Lewisham Gateway

Lewisham H : 9 year old Design Defects

Notes on Detailed Design

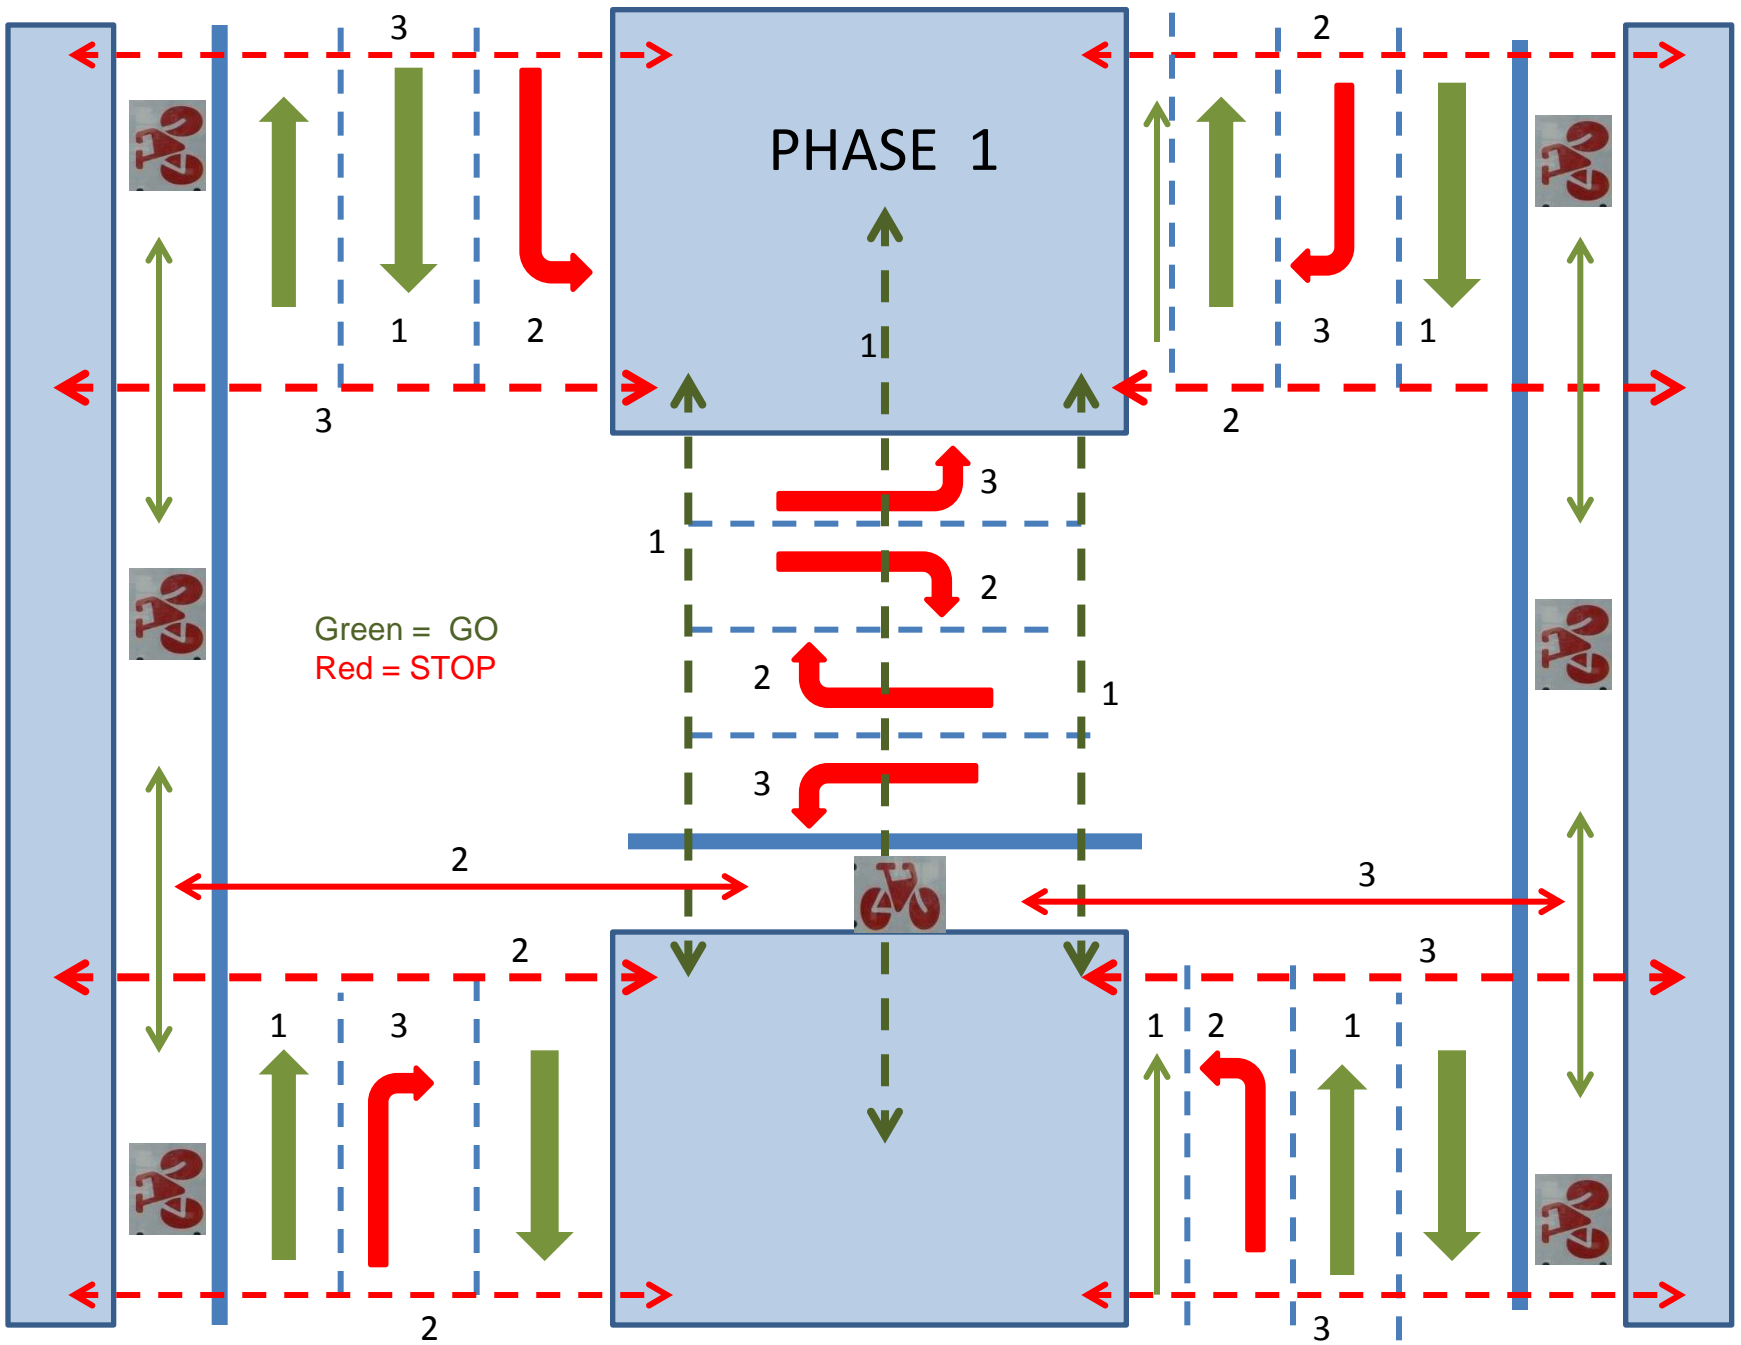
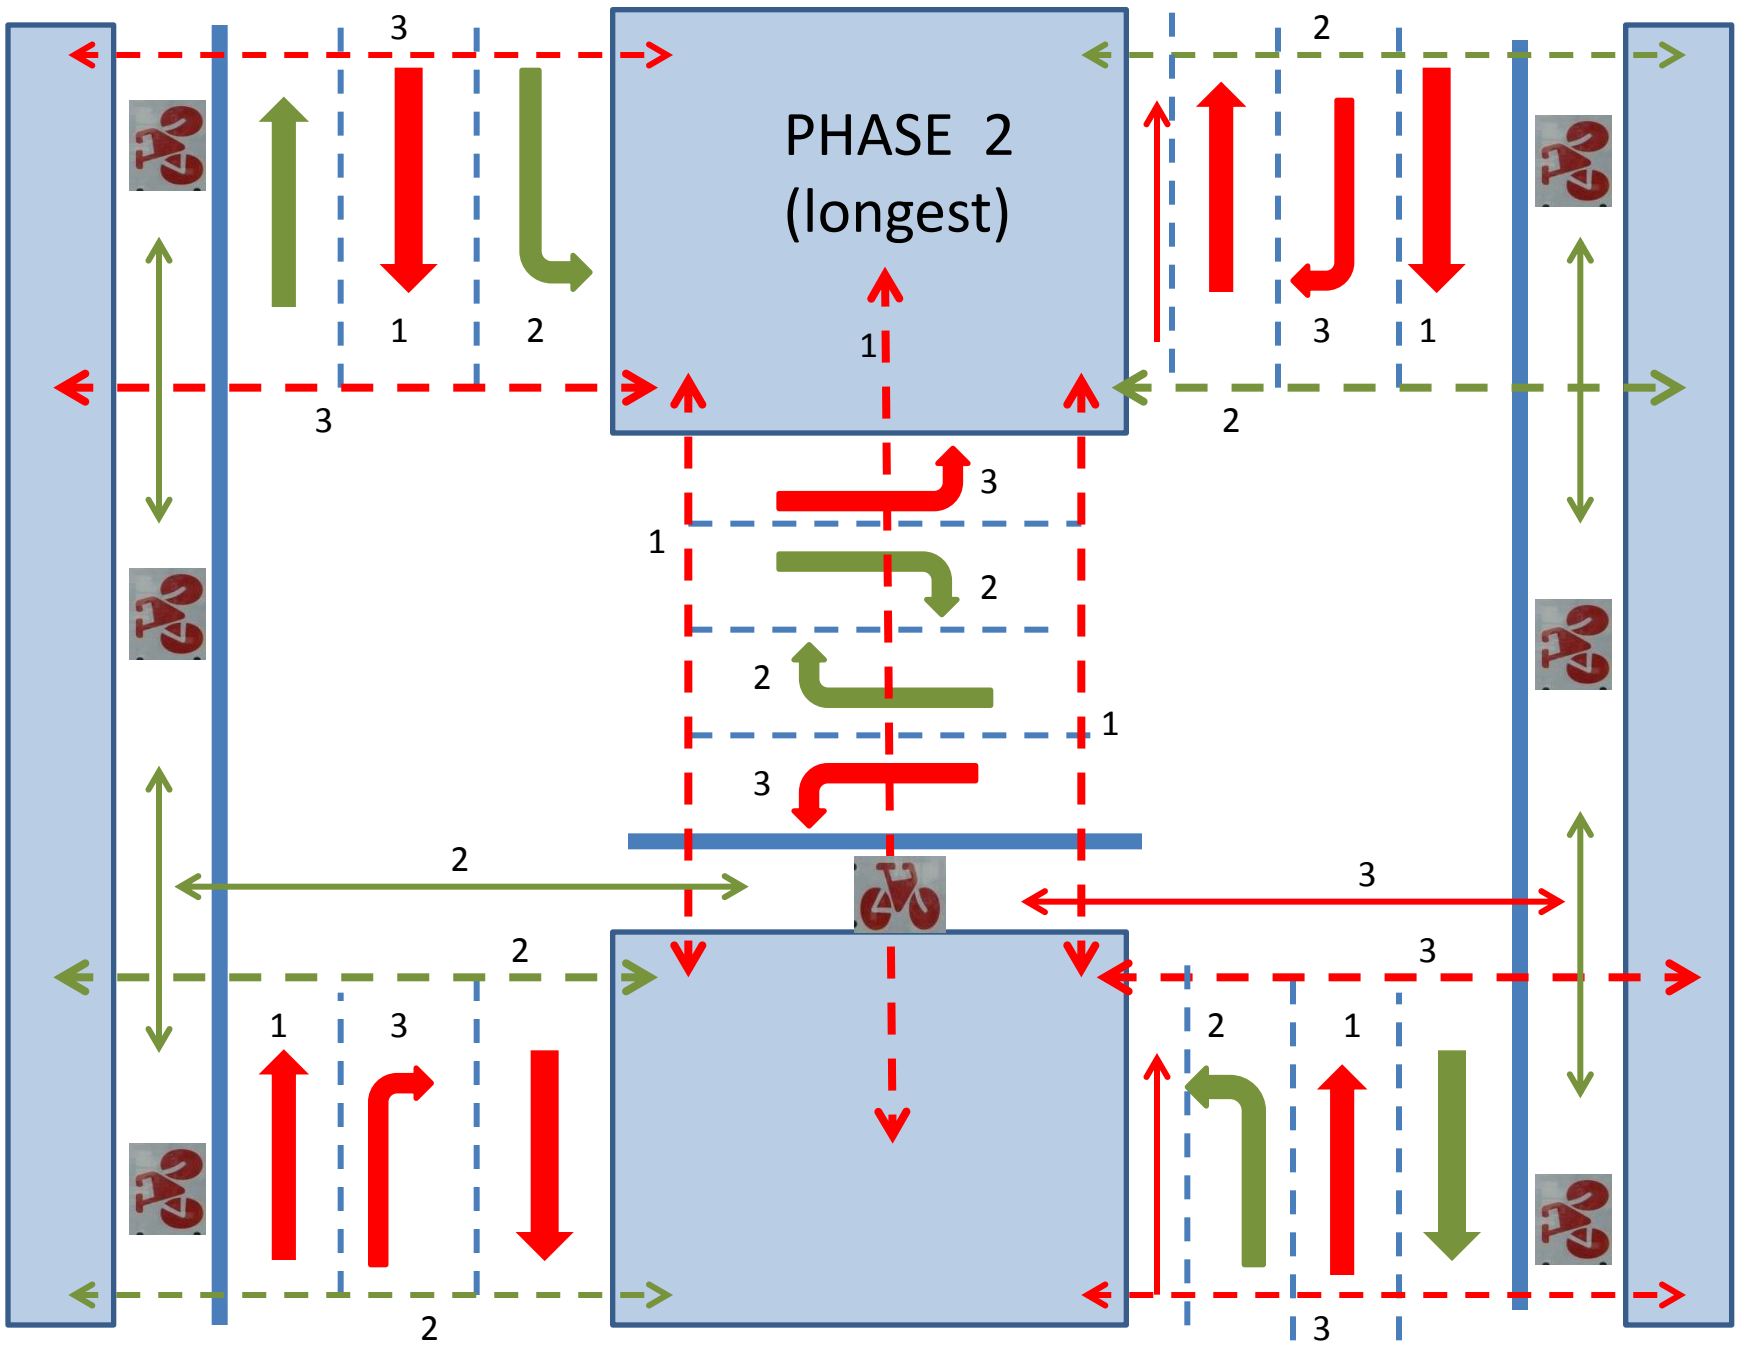
- ❖ **Few crossings ; all 2 or 3-phase**
- ❖ Existing pelicans overloaded
- ❖ Redundant traffic lanes
- ❖ Mixed L/A/R lanes inefficient
- ❖ **High/Low flows get same time**
- ❖ No E-W cycle route (anywhere)
- ❖ Dangerous ASLs; not joined up
- ❖ **High risk left hooks (x4)**
- ❖ Multiple stops/starts delay drivers
- ❖ ***New toucan out of sync***

- ✓ Upgrade crossings to shopping centre [direct 1-phase
 - Minimise ped.crossing distances [no islands
- ✓ Upgrade station access @ Glassmill [2-way cycling
- ✓ Synchronise crossings into centre / station
 - No impact on traffic flow [share same green time
- ✓ Dominant flow gets longer time [**A20E – A20W**
 - Two traffic lanes only on approaches [extra lane redundant
 - Single traffic lane only on each exit [space for cycle lanes
- ✓ Upgrade Cycle tracks: carriageway level [not on pavement
- ✓ N-bd Cycles on E-side need 1-way lane [not shown above
 - No impact on traffic flow ; ample space
- ✓ Scope should include nearby Junctions [esp. Thurston

- ✓ Single phase ; Longer green
- ✓ **More pedestrian crossings**
- ✓ Less lanes ; Early separation
- ✓ L only / A only / R only
- ✓ **More time for A20 traffic**
- ✓ 2-way track S-side
- ✓ As Latest CSH Designs
- ✓ **No left / right hooks**
- ✓ Sync: Improved traffic flow
- ✓ ***Time sharing***
